STAFF RECOMMENDATION
405 N Wilson Boulevard
September 20, 2017

Application: Demolition; New construction - infill
District: Cherokee Park Neighborhood Conservation Zoning Overlay
Council District: 24
Map and Parcel Number: 10308024800
Applicant: Manuel Zeitlin, architect
Project Lead: Sean Alexander, sean.alexander@nashville.gov

Description of Project: An application to demolish a non-contributing house and replace it with infill. The new house will be one and one-half stories with a steep cross gabled roof and a recessed vestibule, features common for the Tudor Revival style.

1 Existing Site Plan - Demolition
1" = 30'-0"

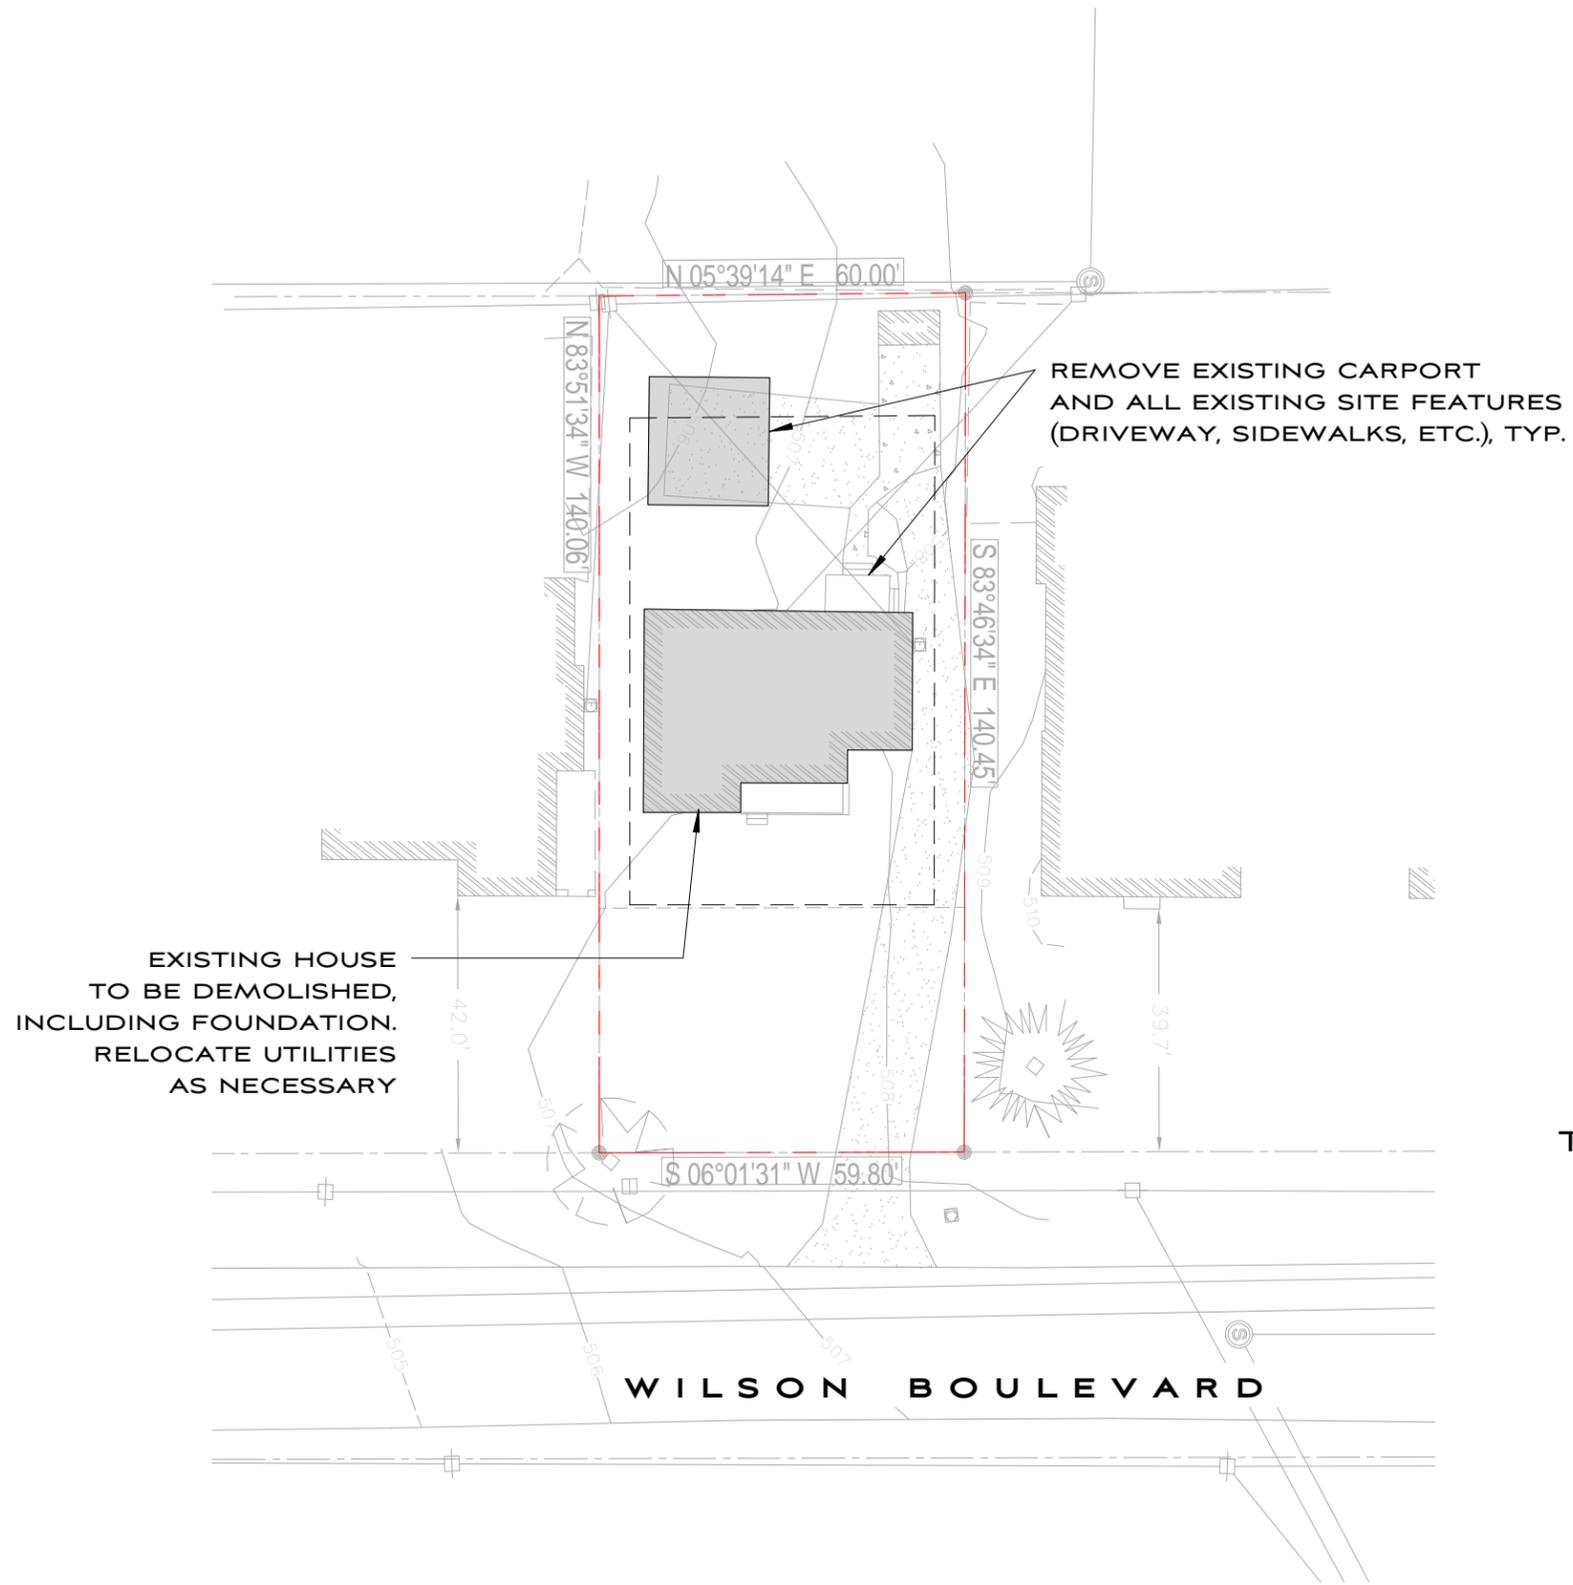
Demolition: Although the existing building at 405 N Wilson Boulevard likely dates to the mid-1940s, its style, form, and detailing do not match the historic context of neighborhood. Its low slope roof, shallow eaves, fenestration pattern, and lack of window trim and other details are inconsistent with the predominant surrounding historic character. In addition, the building is not a good example of its period of development. Staff therefore finds that the structure does not contribute to the architectural and historical character and significance of the district, and that its demolition meets section III.B.2 for appropriate demolition and does not meet section III.B.1 for inappropriate demolition.

ELEVATIONS	A 3
9-05-17	1747

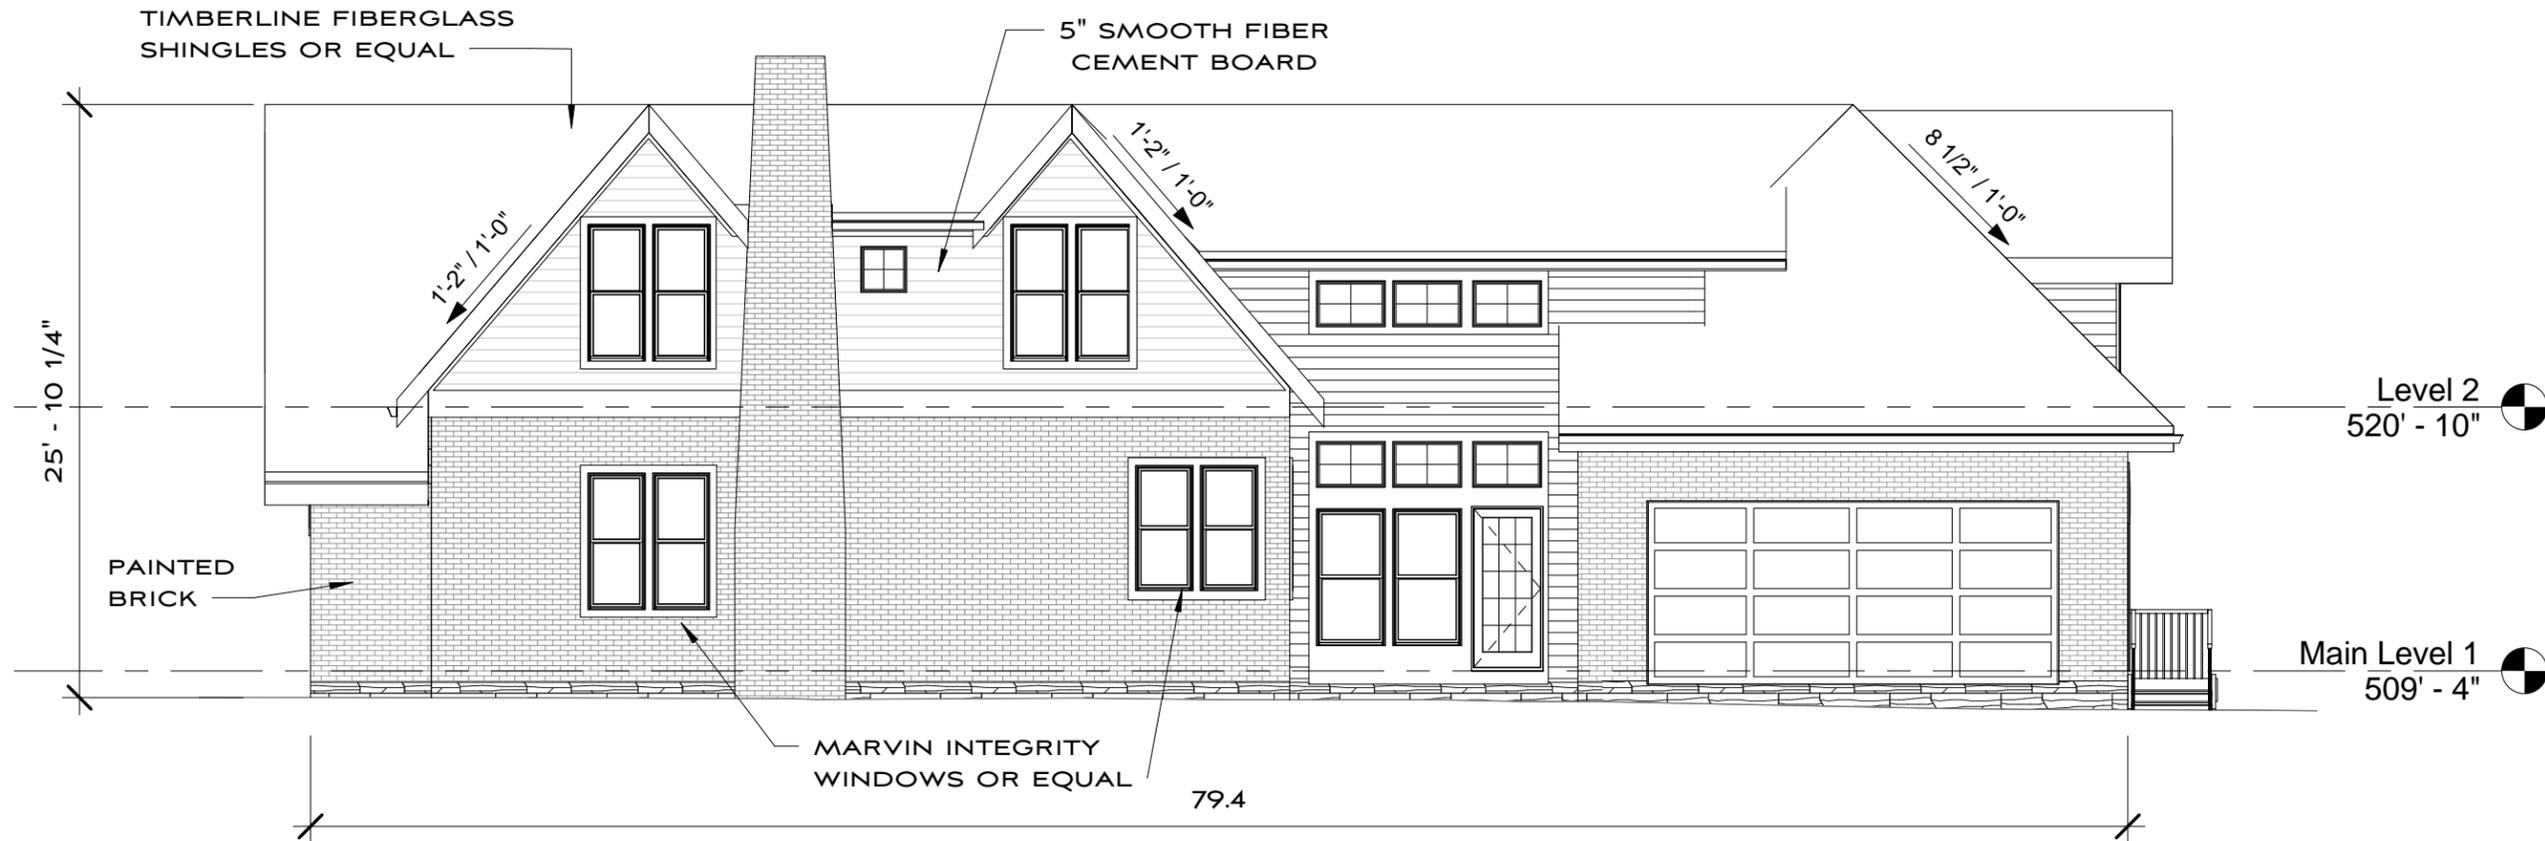
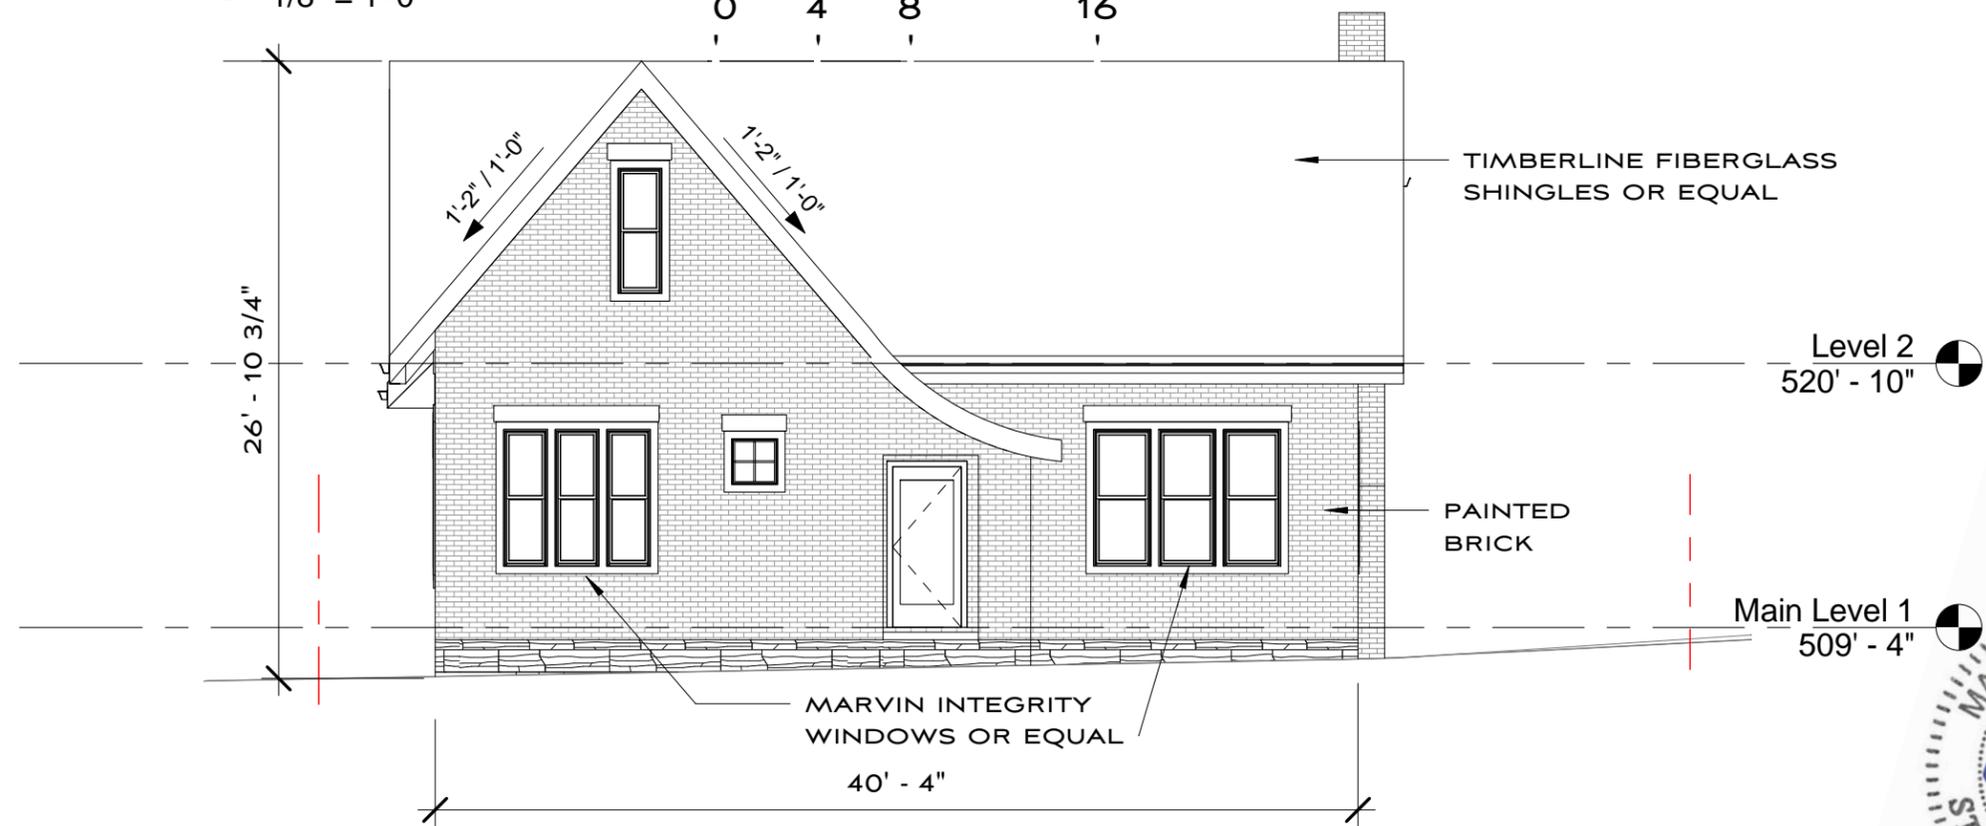
Height & Scale: The proposed infill will be a one and-one-half story house with a roof height of twenty-six feet (26') above the typical grade. The eave height will be approximately twelve feet (12') above grade, with an exposed foundation of one to two feet (1' to 2') depending on grade. These heights are compatible with surrounding historic context, which comprises one and one-half story houses ranging from twenty feet (20') to twenty-six feet (26') tall.

Roof form: The roof will be a cross-gable, with a primary ridge orientation to the sides and projecting gable to the front. These roofs will have a steep pitch of 14:12, similar to the roofs of several historic Tudor Revival style houses nearby. Behind the primary front roof components will be a rear wing with a hipped roof and dormers with lower pitches. These roof forms are also common throughout the neighborhood, and will be largely obscured by the primary mass of the building. Staff finds the roofs of the new building will meet section II.B.1.e of the design guidelines.

Orientation: The building will address the street with the front façade parallel to the street, matching nearby historic houses. It will not have a prominent front porch, but will have a recessed gable within the front projecting wing as is typical of the Tudor Revival style. A walkway will lead from the vestibule to across the front yard and connect with the driveway, similar to the condition of nearby houses. Staff finds the orientation to be compatible with the surrounding historic context and to meet section II.B.1.f of the design guidelines.

Proportion and Rhythm of Openings: The majority of windows on the proposed infill are generally twice as tall as they are wide, as is typical of windows on historic houses. There will be a square window on the front façade and a horizontal row of three square windows on the left façade. While not typical of many styles, smaller and shorter windows are common on Tudor Revival houses like the current proposal. There are no large expanses of wall space without a window or door opening. Staff finds the project's proportion and rhythm of openings to be appropriate and to meet Section II.B.1.g.

1. The foundation and floor height are consistent with adjacent historic houses, to be verified by MHZC Staff during construction;
2. Samples of the stone and brick materials, as well as the roof color and paving materials are approved administratively;
3. The window and door selections are approved administratively prior to purchase; and,
4. HVAC units shall be located on the rear façade, or on a side façade beyond the midpoint of the house.
